**Frequently Asked Questions:  
Test Requirements for  
Advanced Grid Support Energy Storage Resources  
(AGS-ESR)**

**Version 1**

**February 2025**

The output active power of the resource and illustration of  $\Delta E$

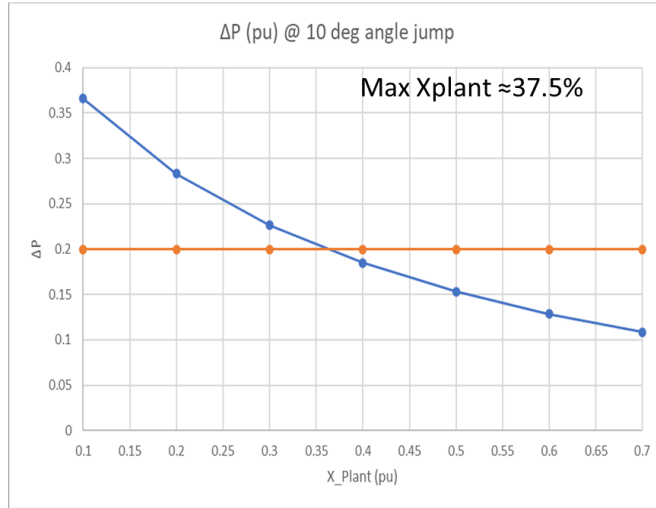
where  $\Delta E$  is the area under the active power production change of the ESR from 0 to 0.5 s in pu. Figure 4 illustrates how to calculate  $\Delta E$  from the active power output of the resource.
